U.S. Department
of Transportation
**Research and
Special Programs
Administration**

Ref. No. 03-0047

This responds to your February 13, 2003 letter requesting clarification on marking requirements in § 172.336(c)(1) in the Hazardous Materials Regulations (HMR; 49 CFR Parts 171-180). Specifically, you ask if your proposed multi-tank cargo tank motor vehicle (CTMV) configuration is eligible for provisions in § 172.336(c)(1) concerning identification number display.

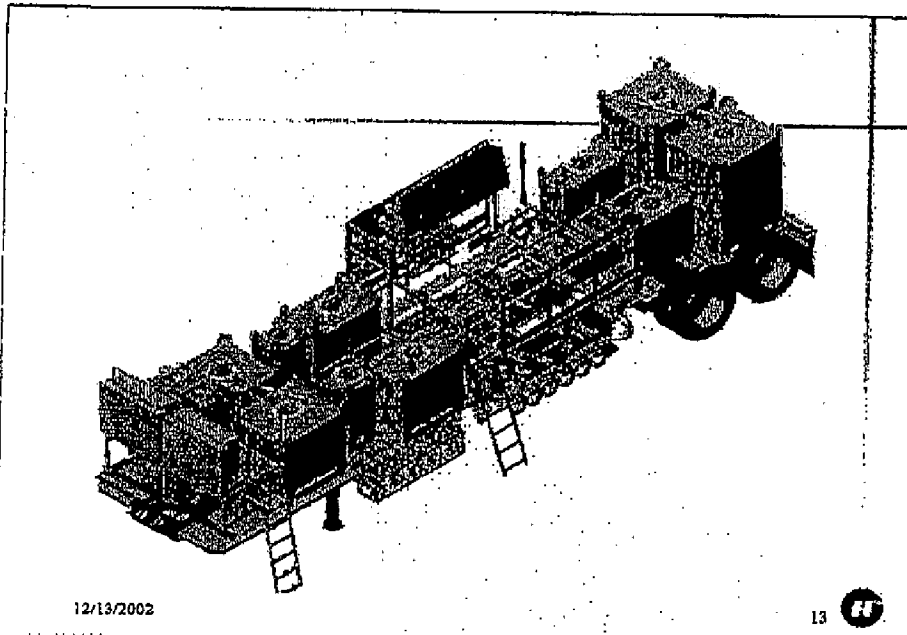
Halliburton is currently in the design phase of a multi-tank cargo tank motor vehicle (CTMV) for use in the oil and natural gas exploration industry. The proposed configuration consists of 10 independently mounted cargo tanks on a trailer chassis, with five tanks mounted on each side. The tanks will have capacities ranging from 150 to 500 gallons. A rough drawing is attached for your review.

Would a CTMV in the configuration below be eligible for the special provision authorized under 172.336(c)(1) concerning ID number display, or would the configuration require that each tank display ID numbers on all four sides? Placards for each hazard class being transported would be affixed to each side and end of the CTMV.

It is the opinion of this Office that your proposed multi-tank CTMV is comprised of separate cargo tanks and is not a "compartmented" cargo tank as referenced in § 172.336(c)(1). Therefore, the provisions of § 172.336(c)(1) do not apply.
